Knocking Noise From Fuel Tank Area

Market USA

YEAR(S)	MODEL(S)	ADDITIONAL INFORMATION
2016 - 2022	RX350

Some 2016 – 2022 model year RX 350 and 2018 – 2022 model year RX 350L vehicles may exhibit a knocking noise from the fuel tank area at idle, vehicle stationary, with a full tank of gasoline. Follow the Repair Procedure in this bulletin to address this condition.

Figure 1. Without Pulsation Damper Valve Assembly Installed

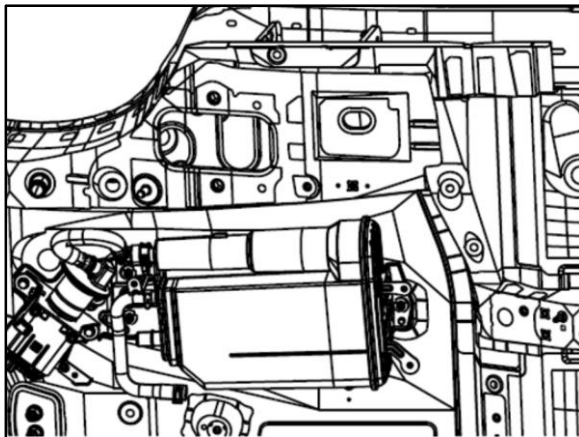
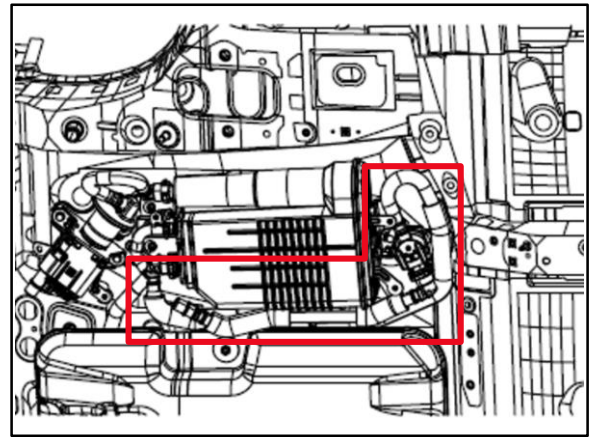
2. Confirm if the vehicle has the NEW pulsation damper valve assembly installed.

The NEW part can be identified by the addition of a bracket and valve assembly attached to the charcoal canister.

Figure 2. With Pulsation Damper Valve Assembly Installed

Figure 3.

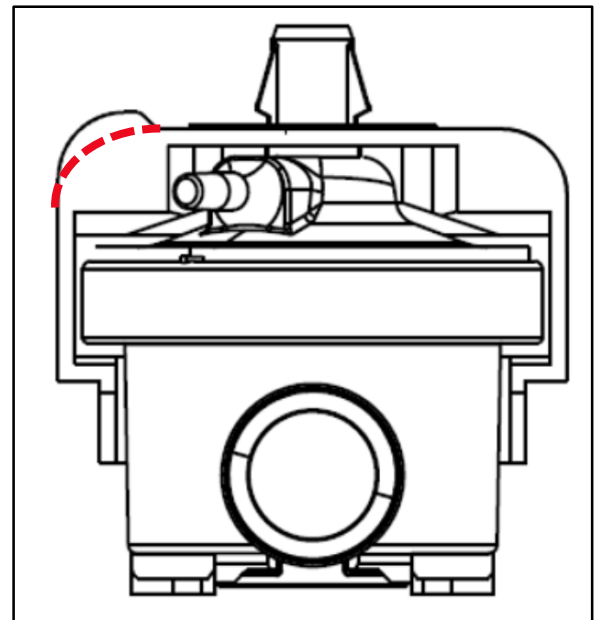
6. To provide adequate clearance to the NEW bracket, trim the NEW pulsation damper valve as shown with scissors or another cutting tool.

Figure 4.

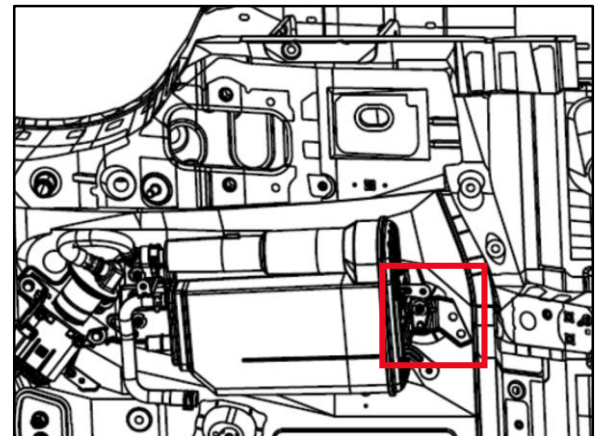
8. Install the NEW bracket to the charcoal canister.
 - A. Remove the nut from the front of the charcoal canister.
 - B. Install the bracket on the stud.
 - C. Tighten the nut and valve assembly plate into place.

Torque: 5.5 N*m (56 kgf*cm, 49 in*lbf)

Figure 5.

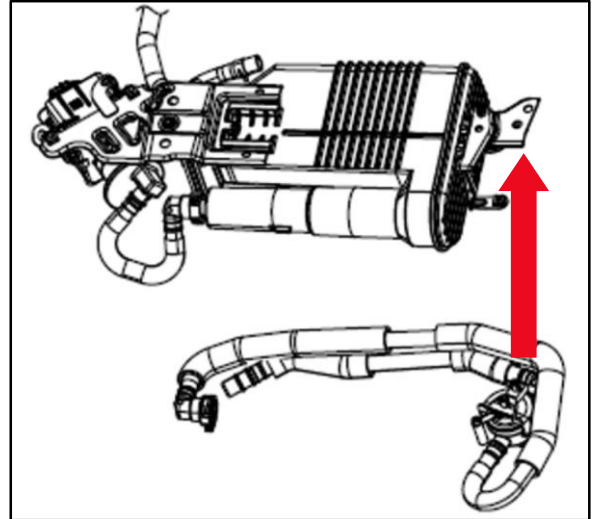
9. Install the NEW pulsation damper valve assembly onto the NEW bracket.
Push both retaining clips of valve assembly through the two holes on the bracket.

Figure 6.

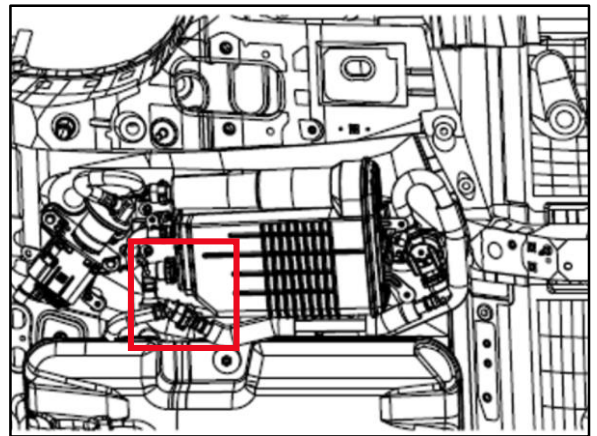
10. Connect the NEW pulsation damper valve assembly between the fuel tank vent hose assembly and the charcoal canister.

Figure 7.

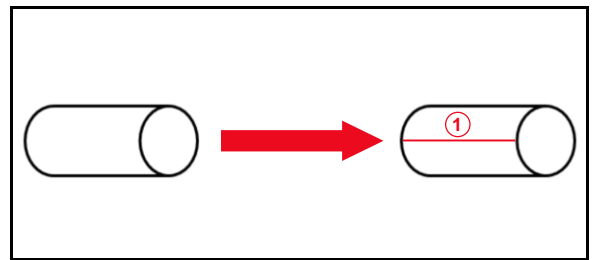
11. Cut the two reflect sleeves as shown.

Figure 8.

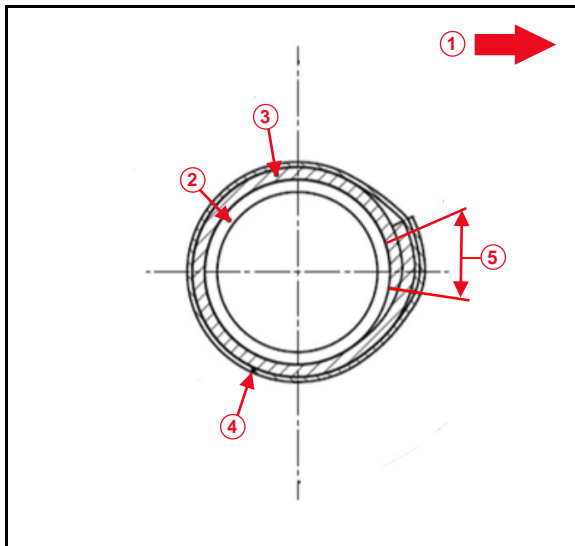
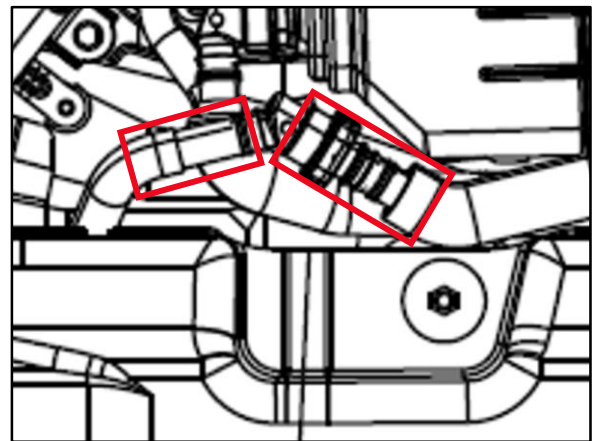
12. Wrap a reflect sleeve around each of the vent tube connections, overlapping the sleeves at the top. Tape the sleeves into place as shown.

Figure 10. Zip-Tie Locations

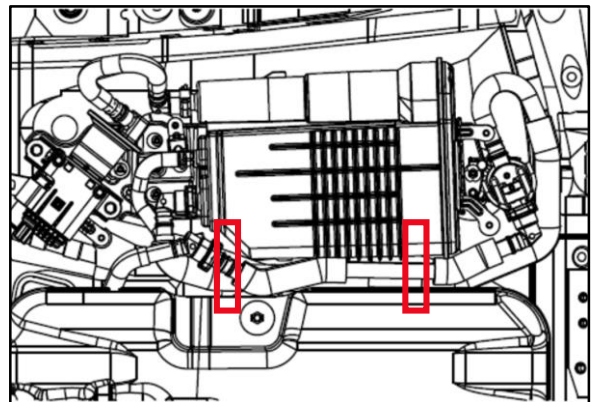
13. Using the zip ties supplied, tie the NEW pulsation damper valve assembly to the purge line as shown by doubling the zip ties together for each location.

NOTE
Double or connect the zip ties to create enough length to secure the assembly.
